Hearings Panel

Worcester Street and Antigua Street Central City Cycleway Connections

AGENDA

Worcester Street (Manchester Street to Fitzgerald Avenue)
Project No.1 - Worcester St
Plan for Approval

Figure 3.6 Pedestrian path across the shared path

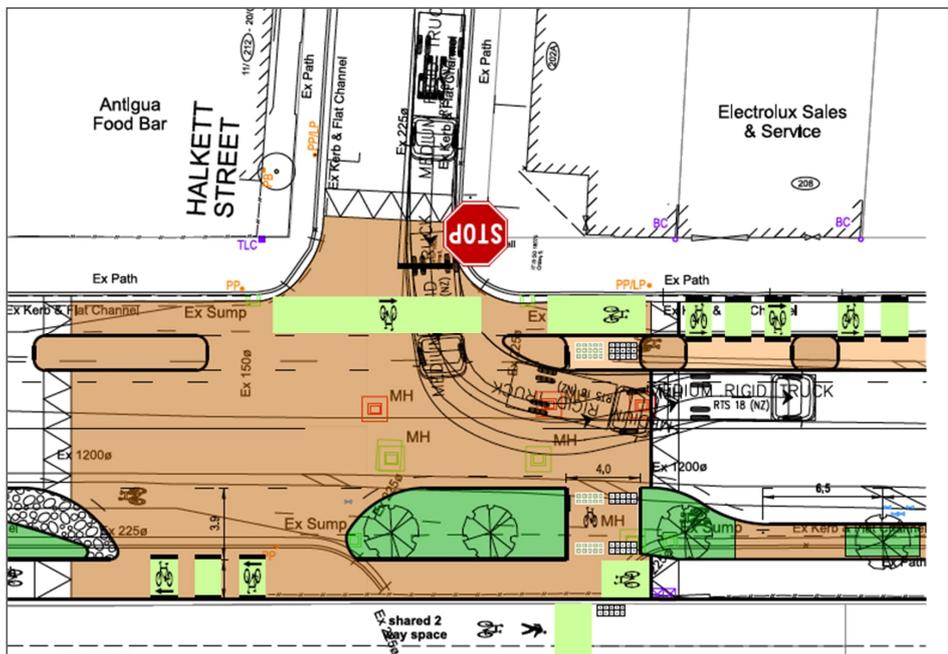
Tracking curves provided by CCC indicate that medium and large trucks turning left from Halkett Street will need to cross the centreline on Antigua Street. However, we note that activities located on Halkett Street are unlikely to be serviced by trucks, except for waste collection, which occurs weekly. It is also unknown whether the refuse collection trucks turn left or right at the Halkett Street intersection. As such, the left turning trucks crossing the Antigua Street centreline is considered acceptable from a safety perspective due to low occurrence and the low-speed environment.

Figure 3.7 Orion substation location

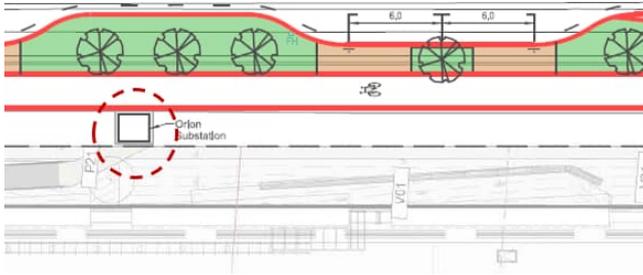
The provided plans show that the Orion substation straddles the entire width of the footpath (see Figure 3.6). It is assumed that this will be relocated. Otherwise, pedestrians will be required to step onto the cycleway, necessitating a short length of a shared path. Given this is a separated cycleway, cyclist will not generally expect pedestrians to step on to their space which increases the risk of a collision between cyclists and pedestrians.

Figure 3.8 Existing Antigua Street 50/ 30km/h threshold

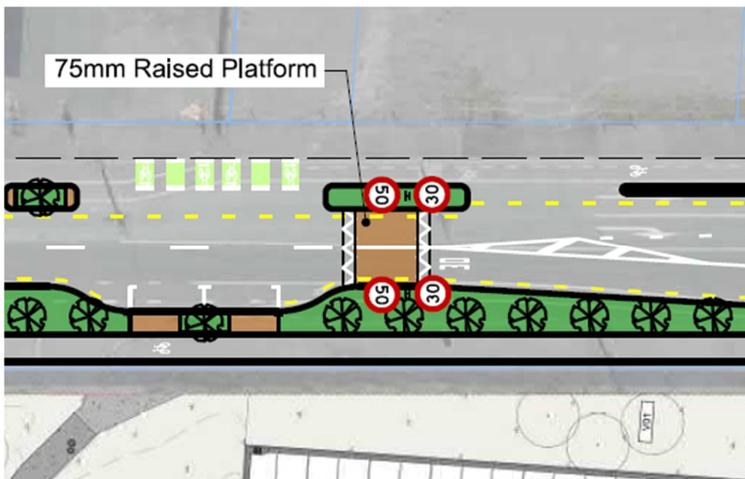
The provided plans show that “30” numeral will be painted on the road surface at the 50/ 30km/h speed limit threshold. However, this is not provided on a red pavement surfacing background as with the current threshold south of the St Asaph Street intersection (see Figure 3.8) and other roads leading to the city centre (Colombo Street, Manchester Street etc.). High contrast pavement colour/ texture changes are very effective at communicating speed limit changes to drivers. As such it is recommended that painting the “30” numeral on red surface marking be considered. This will also result in more consistency in the 50/ 30km/h thresholds leading to the city centre.
